ADDENDUM IV

Date of Addendum: April 29, 2022

Project Name: UNCW Randall Library Expansion and Renovation

SCO # 18-19656-02A

SHEET:
TU100

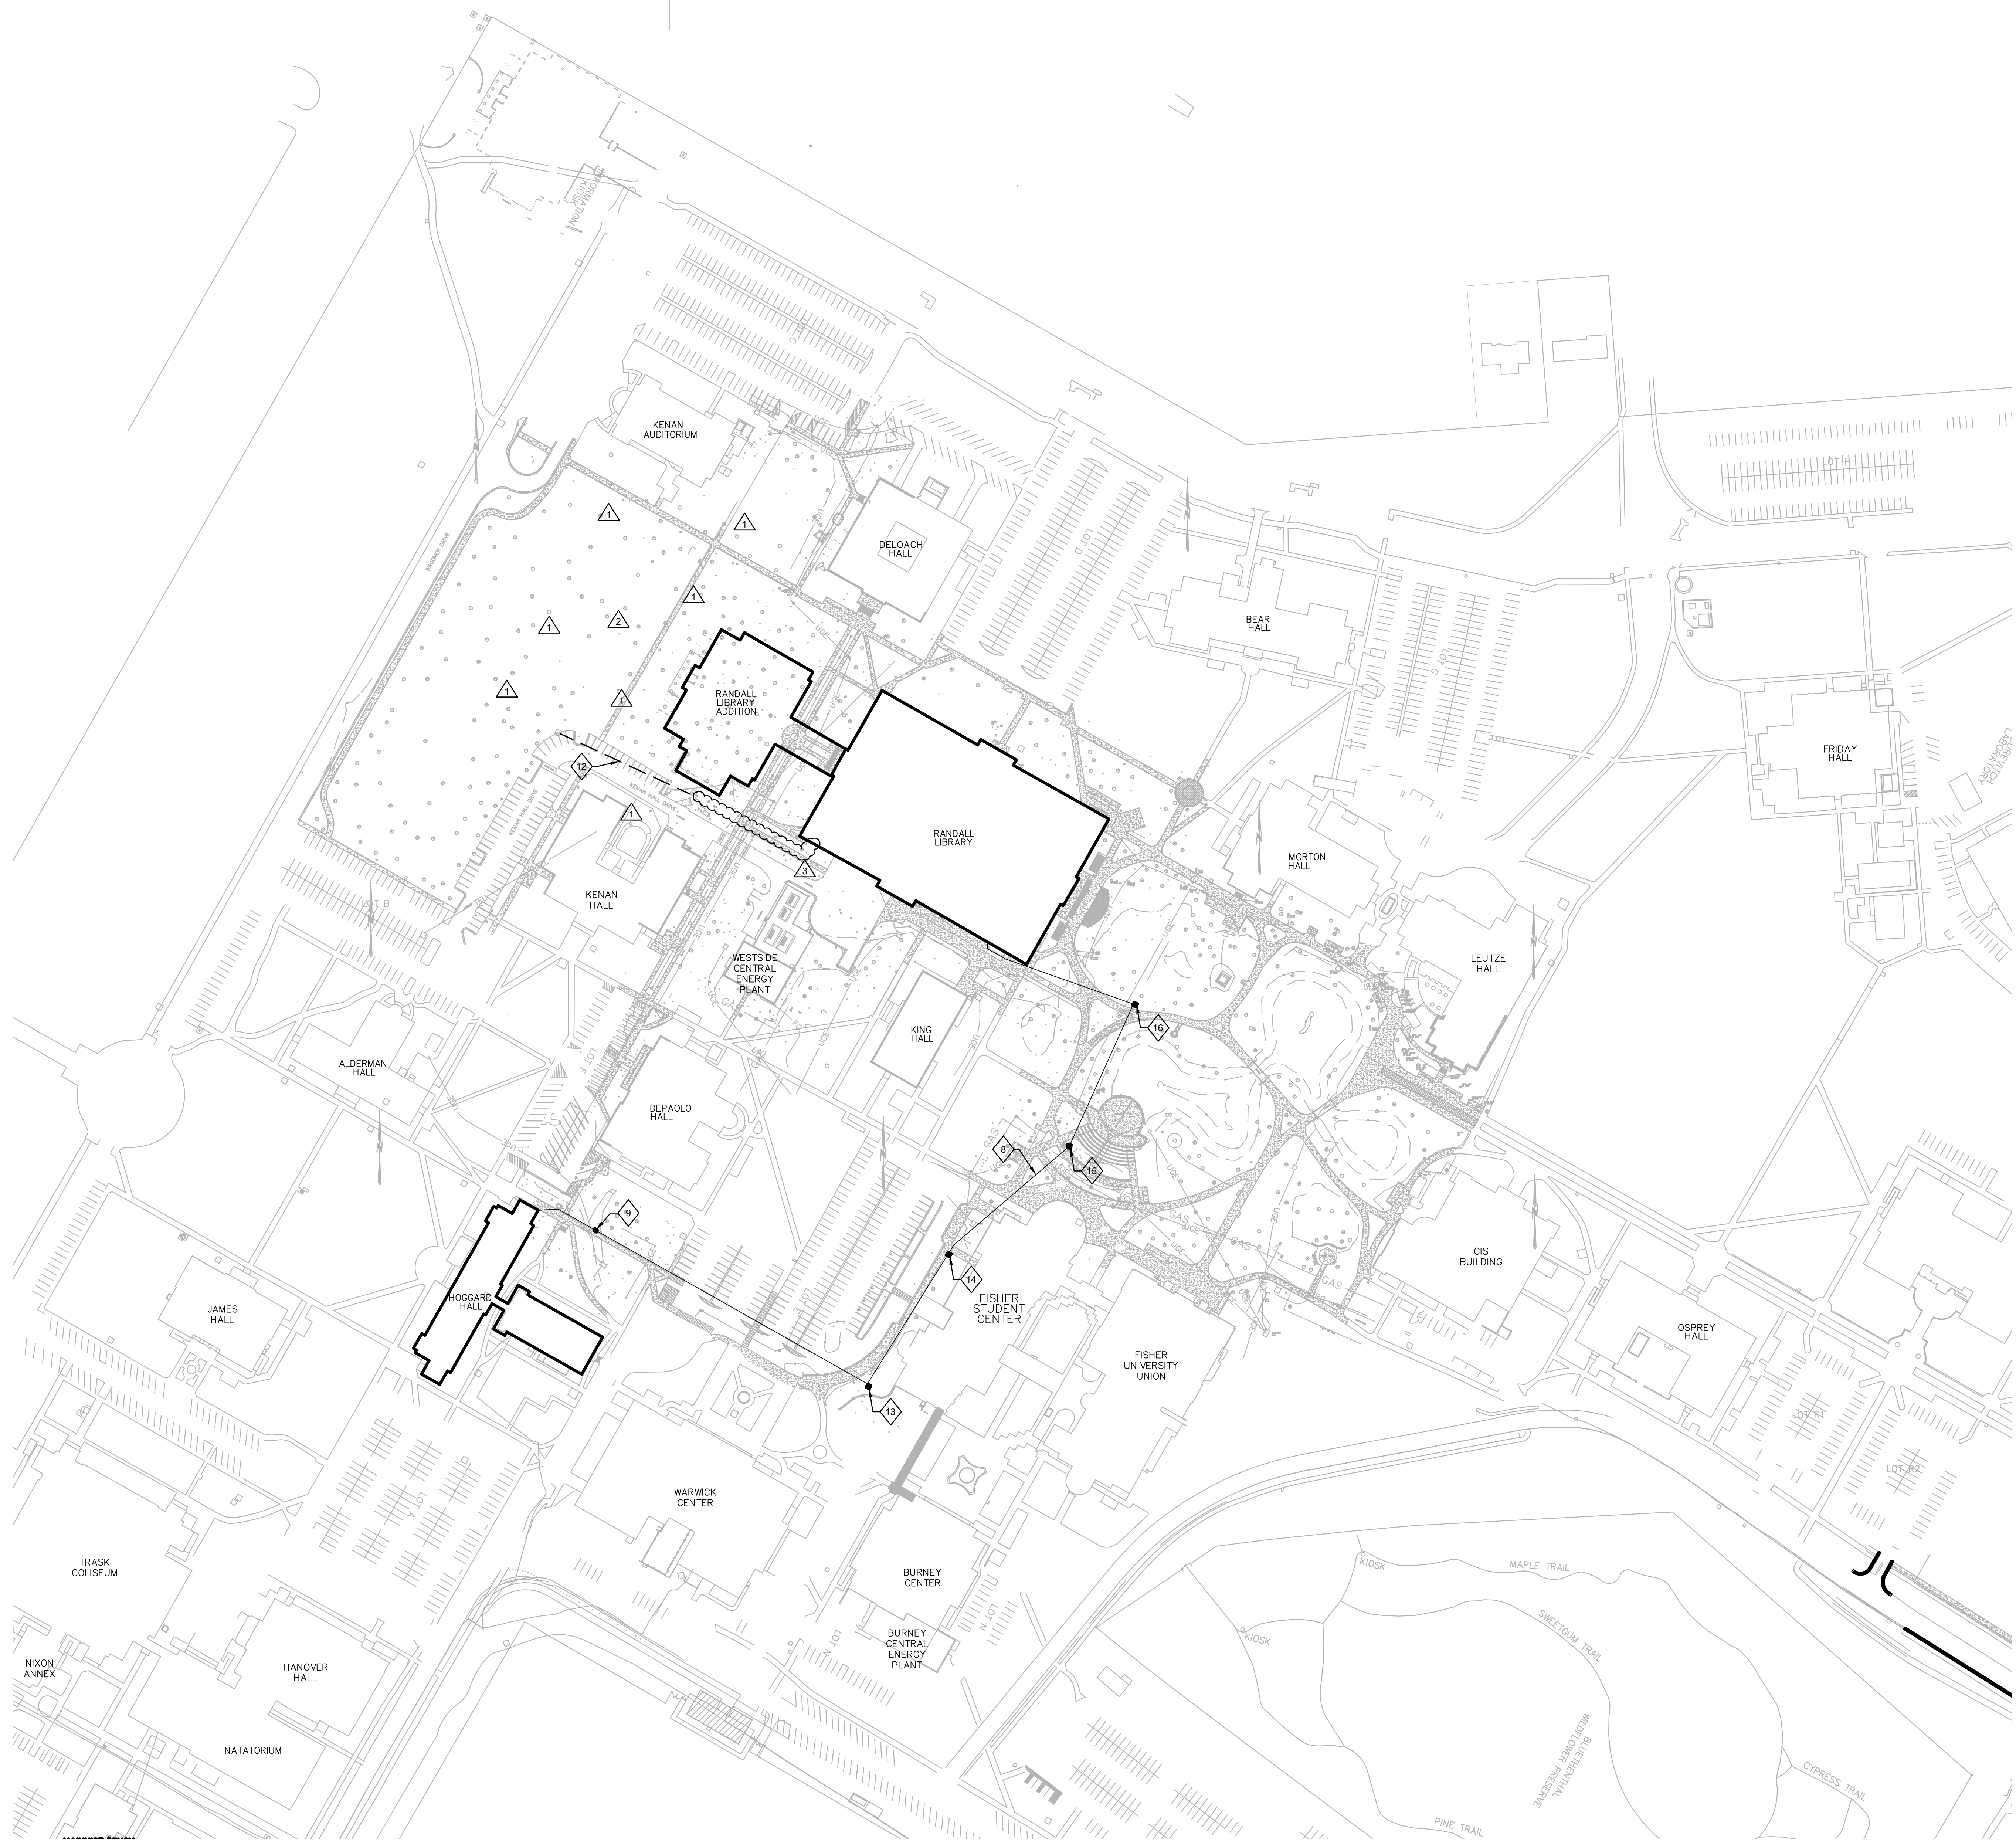
Item IV-14. Sheets TU100, TU101: Replace with revised sheets, included. Updated utility routing per UNCW direction.
